State of New Mexico
Energy, Minerals and Natural ResourcesForm C-103
Revised July 18, 2013OIL CONSERVATION DIVISION
1220 South St. Francis Dr.
Santa Fe, NM 87505

SUNDRY NOTICES AND REPORTS ON WELLS

Dugan Production plans to plug and abandon the well per the attached procedure.

Operator: DUGAN PRODUCTION CORP PO Box 420 Farmington, NM 87499	OGRID: 6515
	Action Number: 450059
	Action Type: [C-103] NOI Plug & Abandon (C-103F)

Planned P & A Schematic

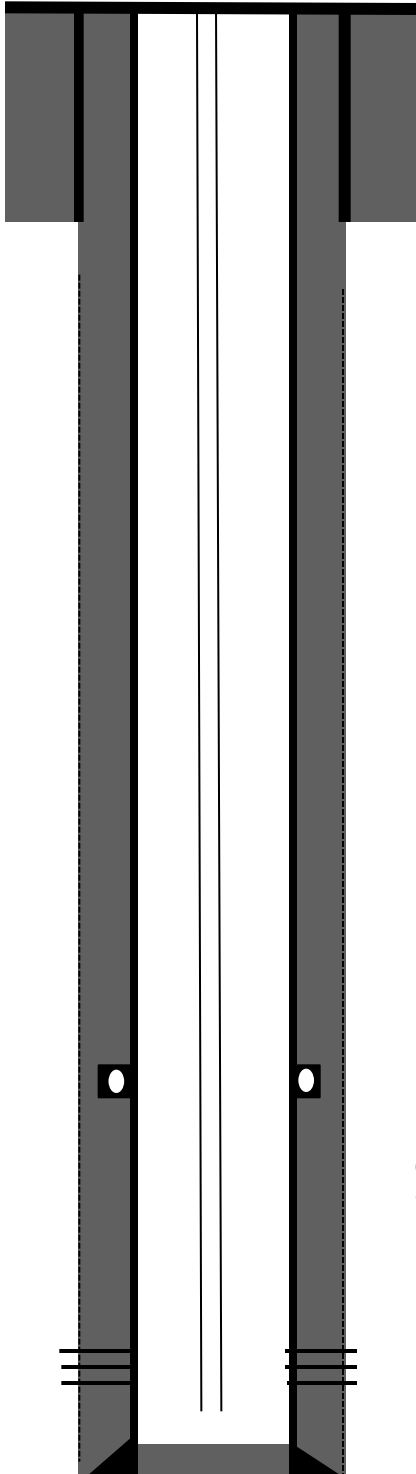
Created By	Condition	Condition Date
mkuehling	NMOCD call upper chacra 1615- Notify NMOCD 24 hours prior to moving on - monitor string pressures daily report on subsequent - submit all logs prior to subsequent.	4/11/2025
